September 22, 2003

Subject: Oconee Nuclear Station  
Docket Numbers 50-269, 270, and 287  
Supplement to License Amendment Request for Full-  
Scope Implementation of the Alternate Source Term  
Technical Specification Change (TSC) Number  
2001-07

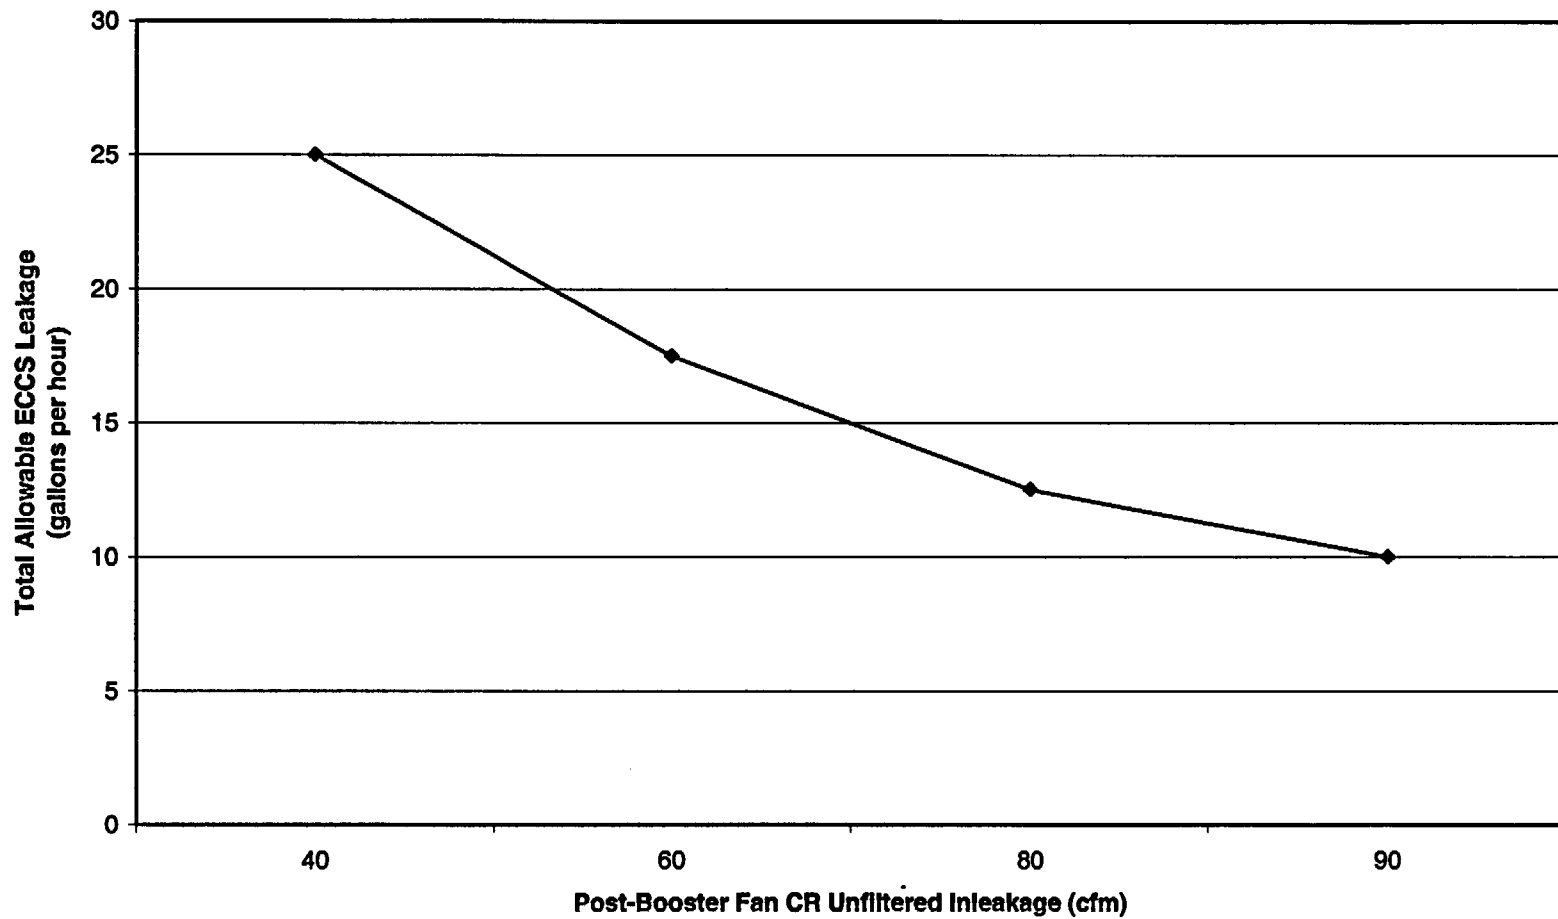
For control room dose, a value of 40 cfm post-booster fan CR unfiltered inleakage will be used as the current licensing basis value based on the most recent tracer gas test results (performed in 2001). For the next tracer gas test planned in the CR Habitability Program, the ONS program for monitoring and controlling total ECCS leakage will determine the current measured total ECCS leakage in the system. This ECCS leakage value will be used to establish the post-booster fan actuation CR inleakage test criteria for the tracer gas test. For example, if total ECCS leakage is measured to be less than 10 gph, a tracer gas test criterion of 90 cfm for post-booster fan CR inleakage will be used. 1150 cfm will remain the pre-booster fan actuation CR unfiltered inleakage licensing basis value. As long as the CR inleakage test satisfies these tracer gas test criteria, CR inleakage and ECCS leakage performance is satisfactory and no past or current operability evaluation or reportability is required.

If the test value for CR unfiltered inleakage has changed, a new value of total ECCS leakage will be determined from the approved curve of total ECCS leakage versus CR unfiltered inleakage. This will apply until the subsequent CR test. The intention of both the CR Habitability and ECCS leakage control programs is to maintain leakage rates at low levels.
